SUBJECT: PLANS AND PROPOSAL ADDENDUMS

PROJECT: F 2B24(123)

CONTROL: 0814-01-036

**PROPOSAL ADDENDUMS**

FM 422  
CULVERT  
PROFILES

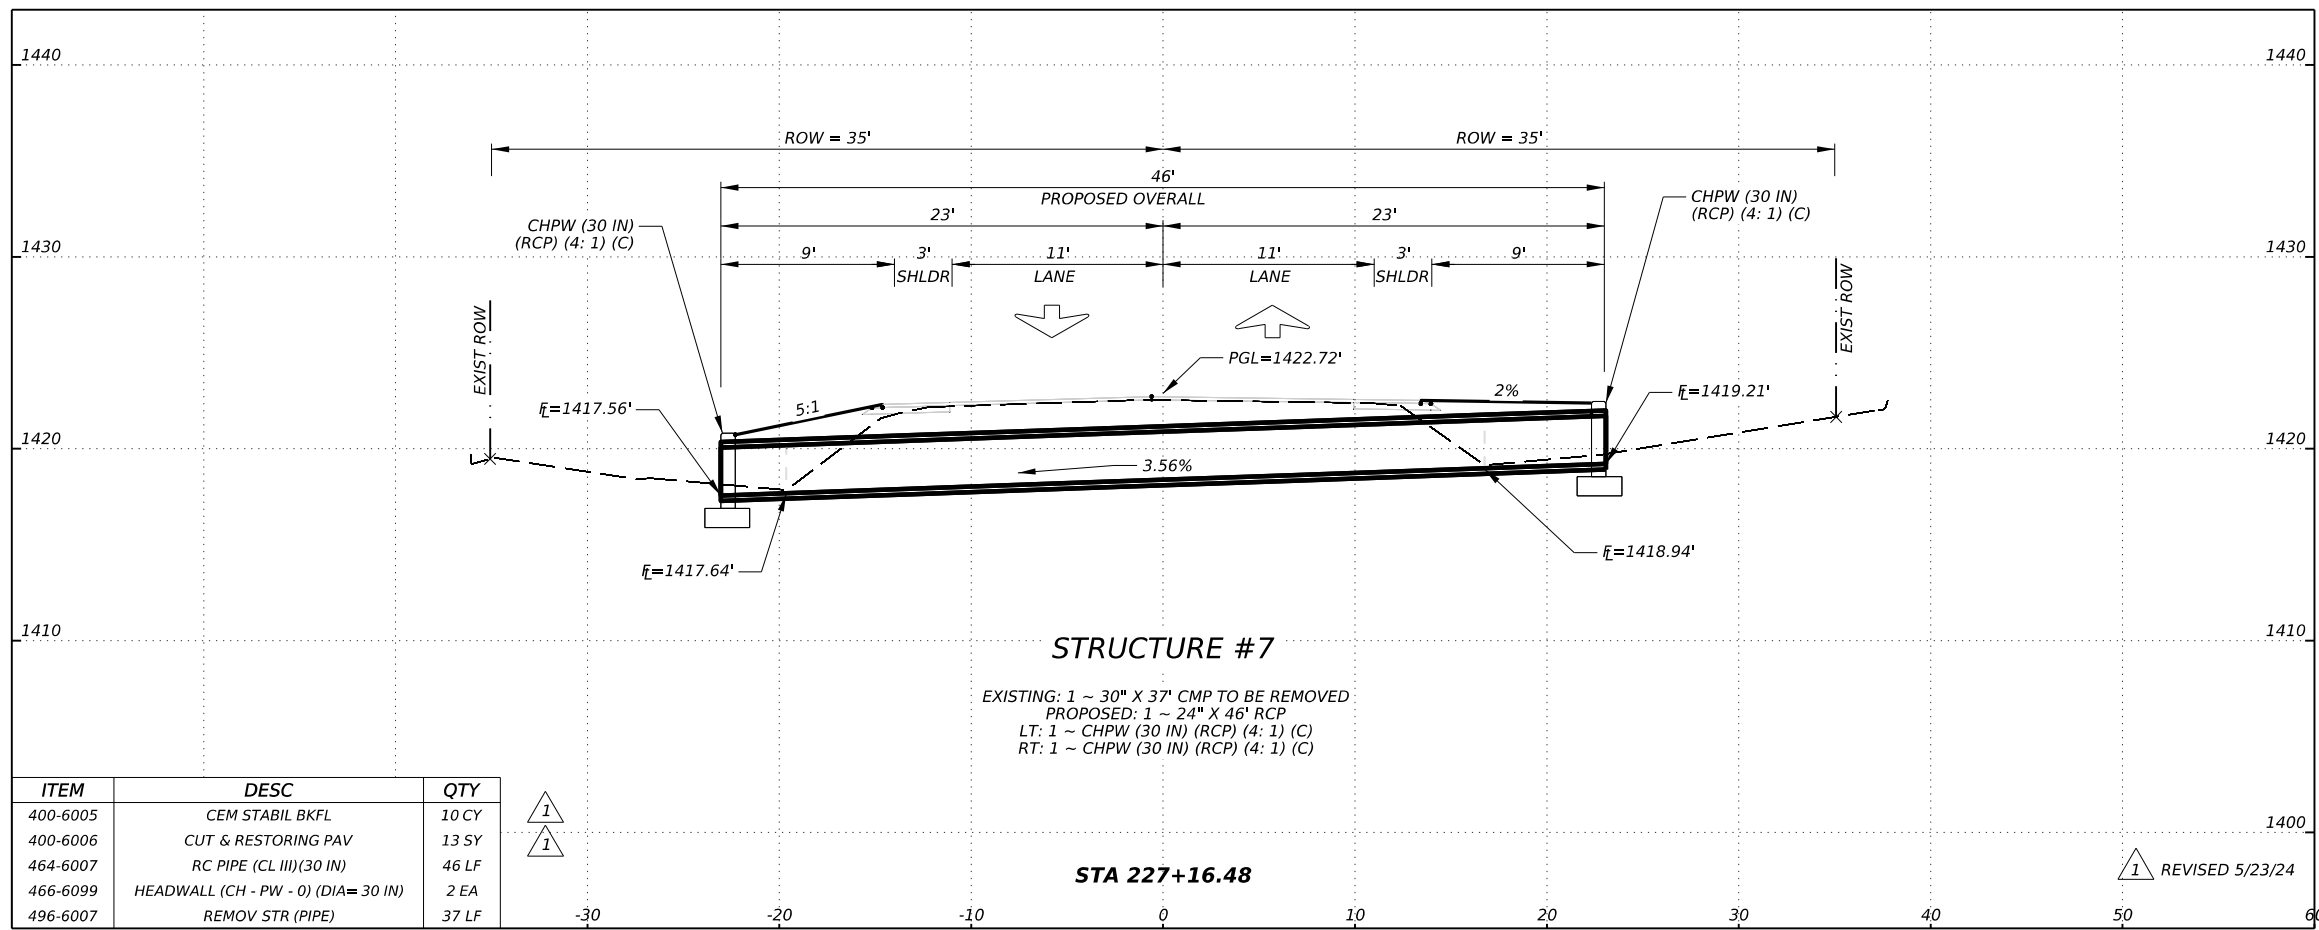
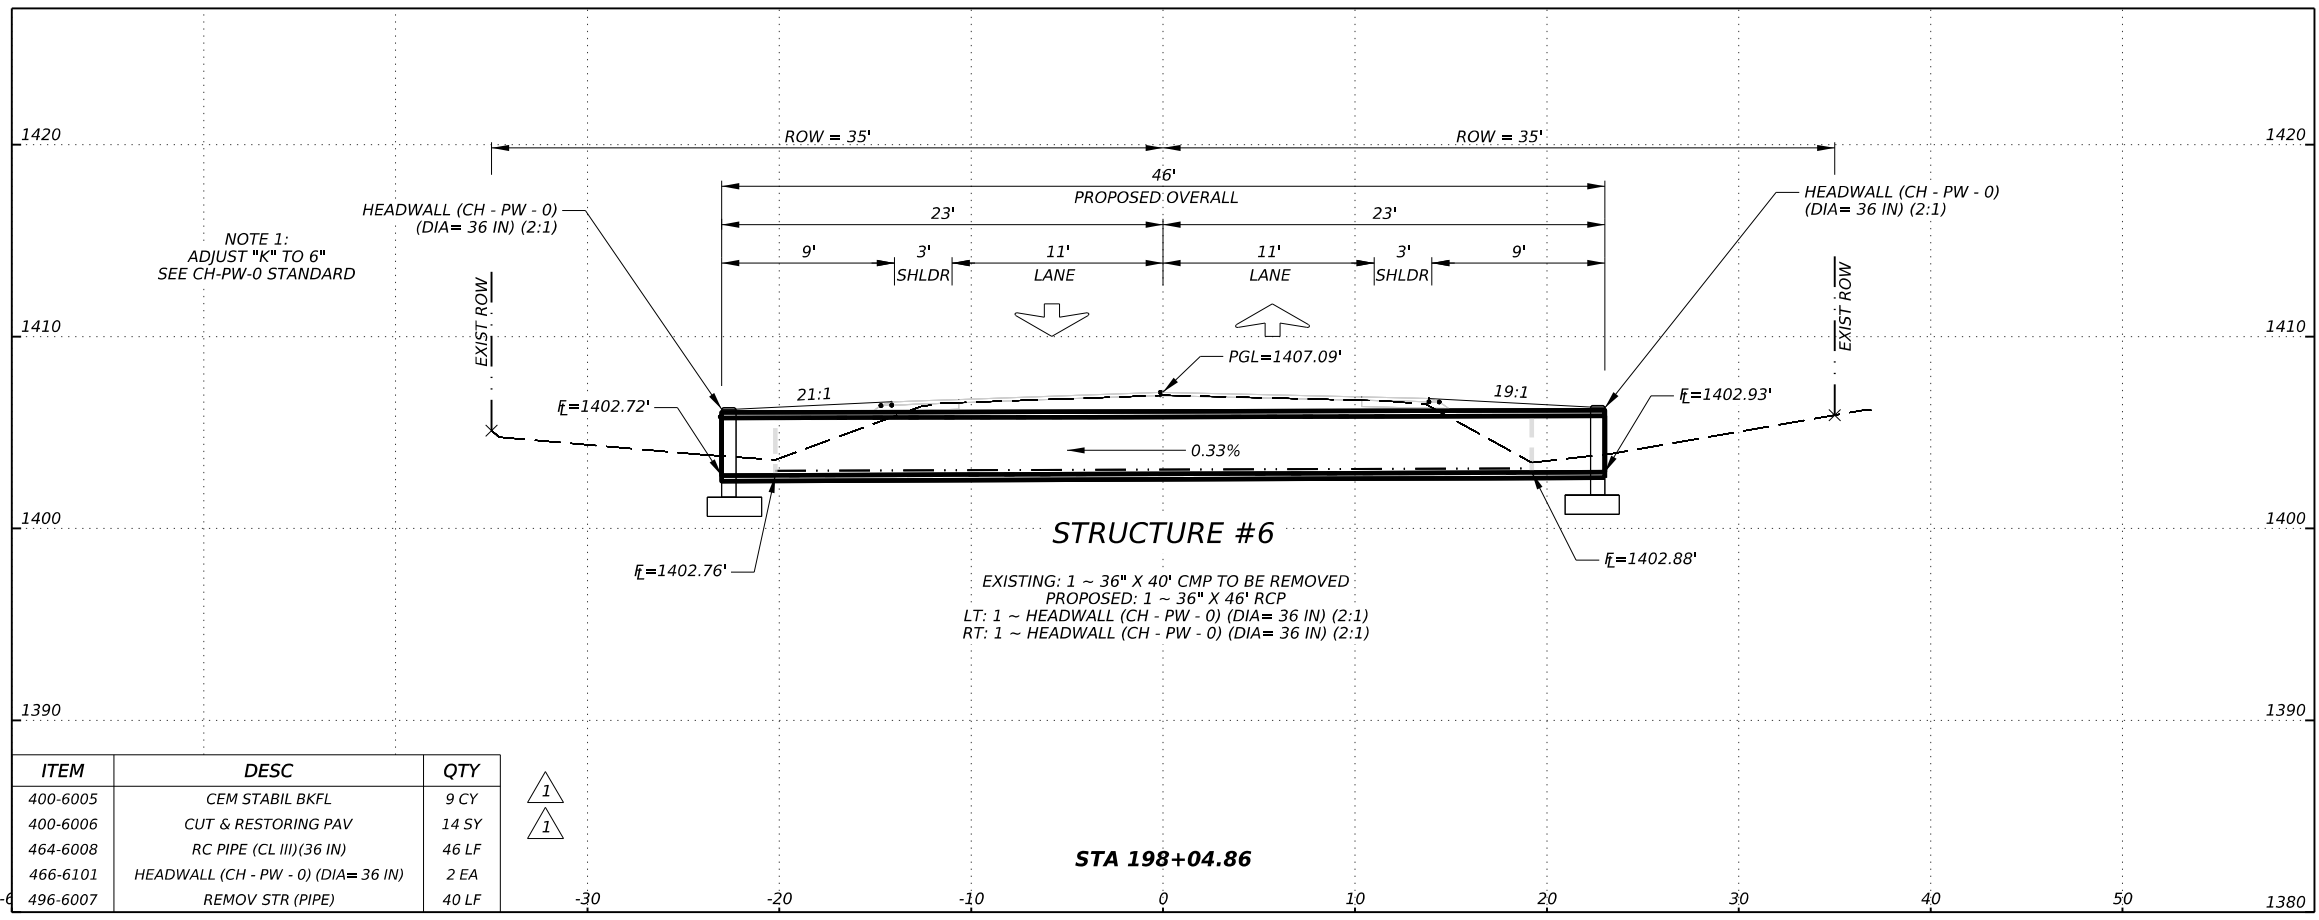
REVISE SHEETS 8, 11-12, 13-15, 74, and 76-82, DUE TO CHANGES ABOVE

REVISD 5/23/24

**FM 422  
 CULVERT  
 PROFILES**

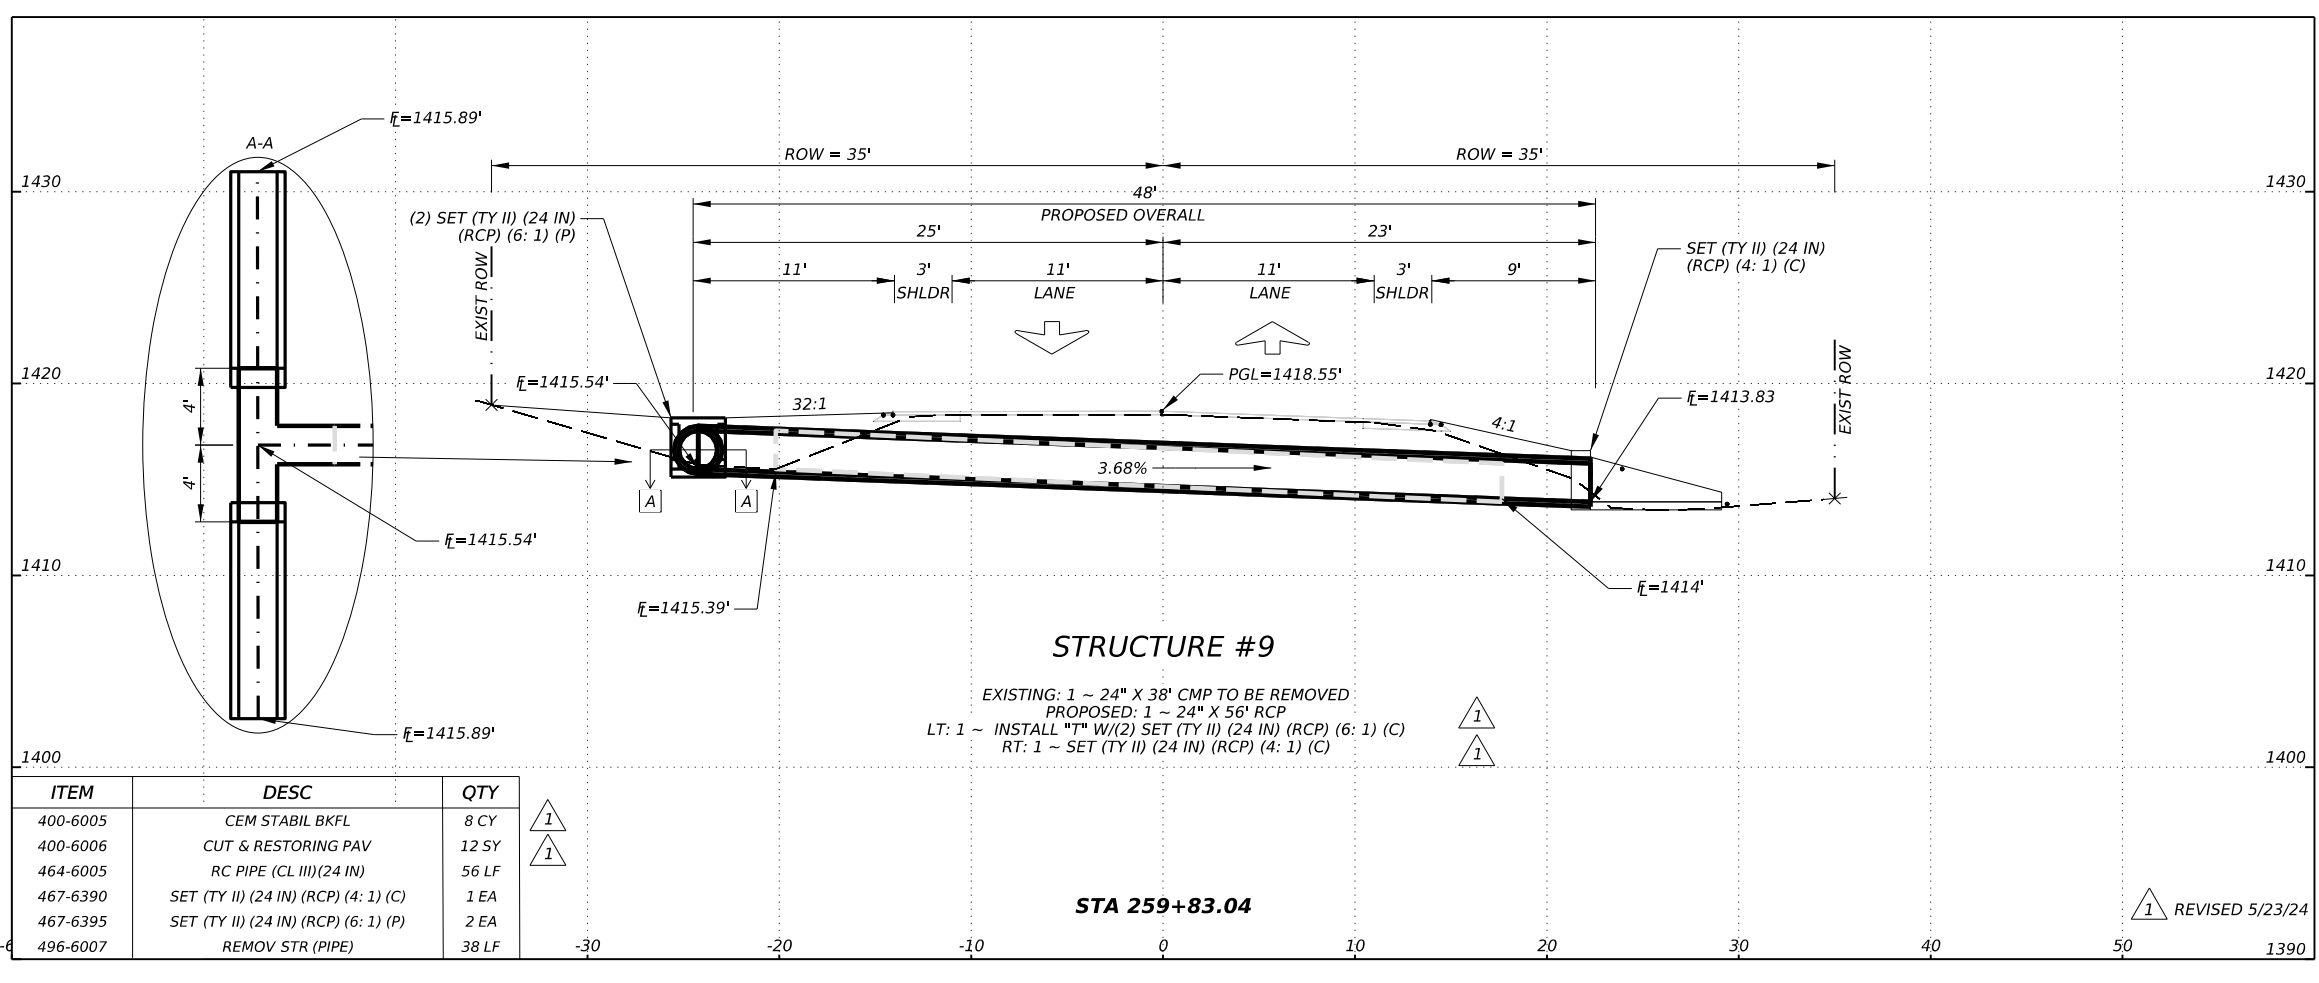
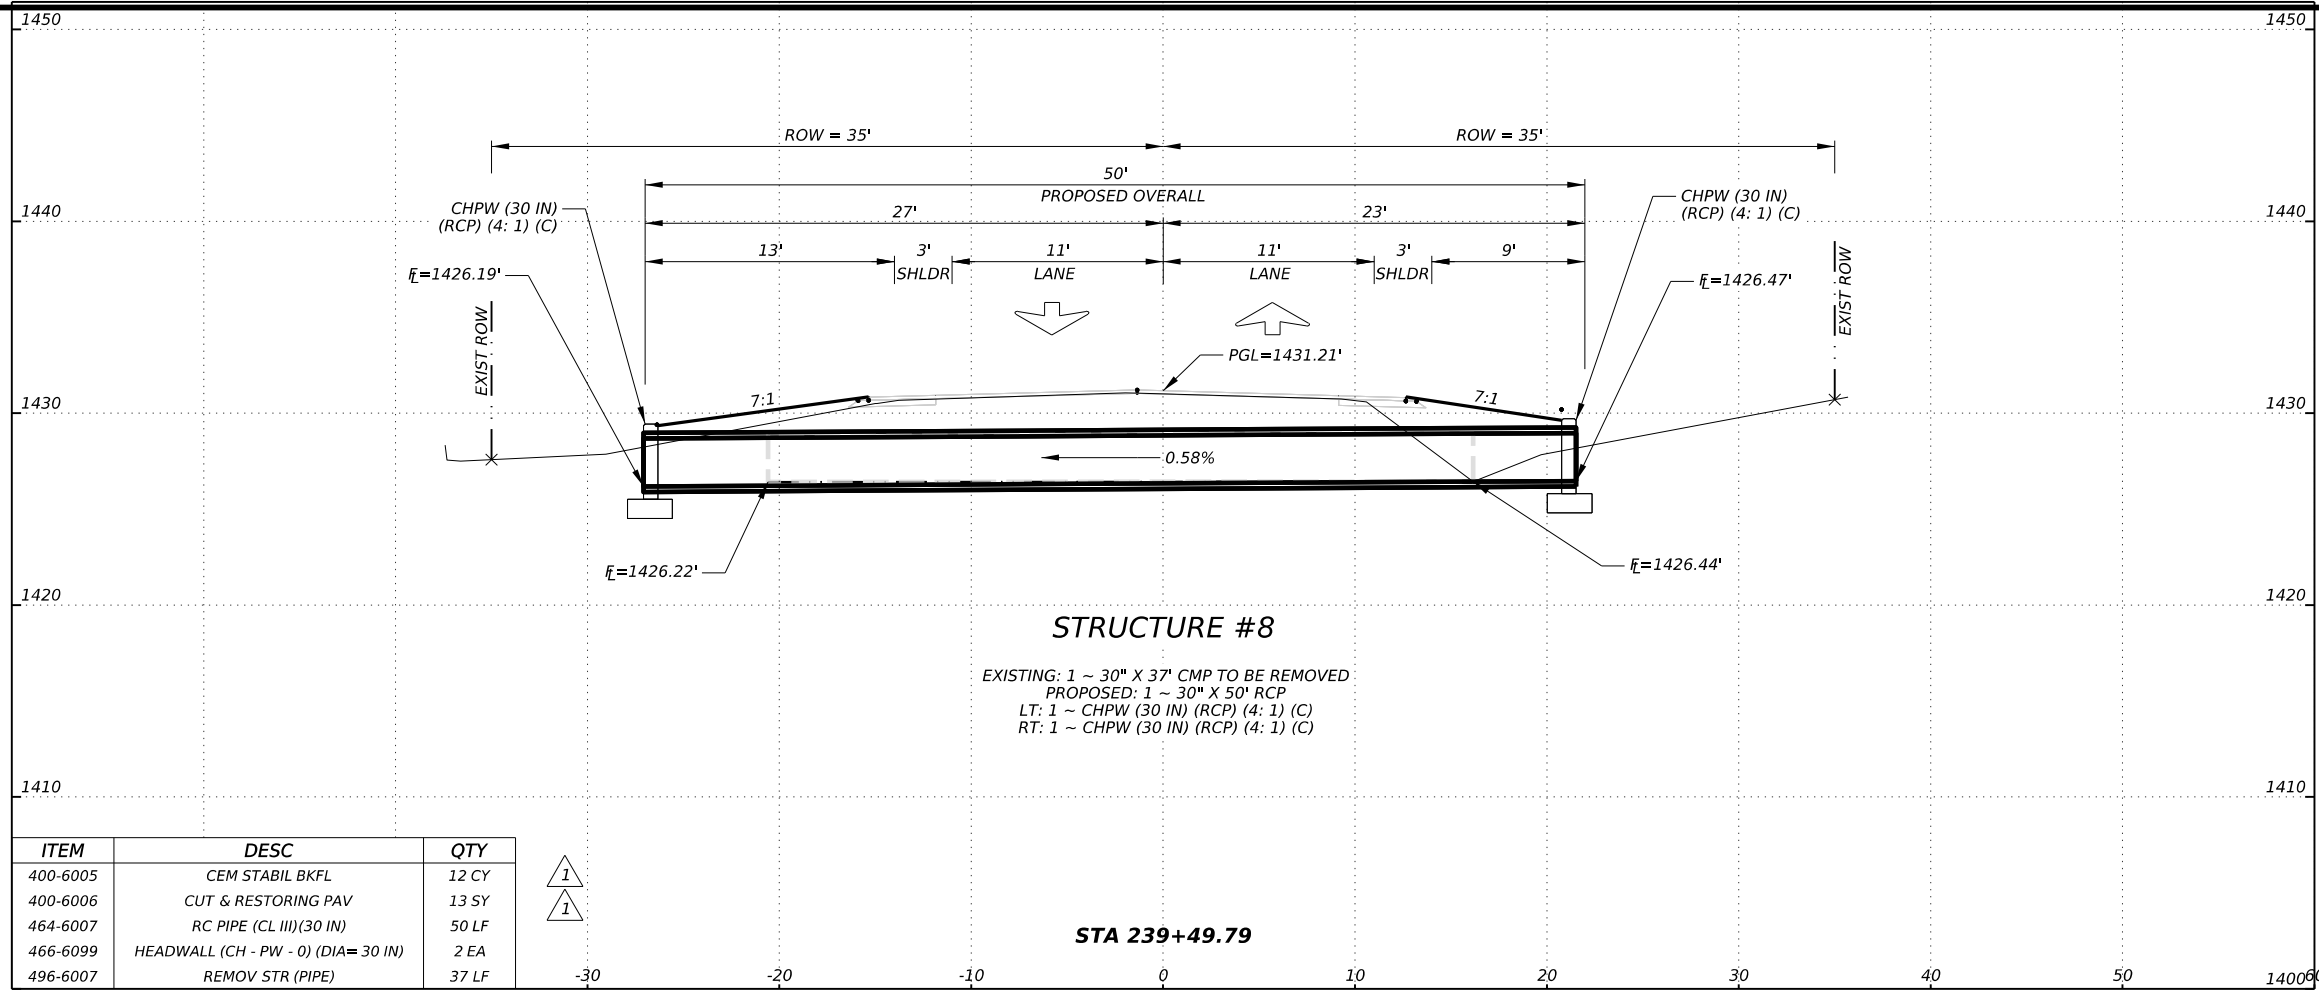
REVISI 5/23/24
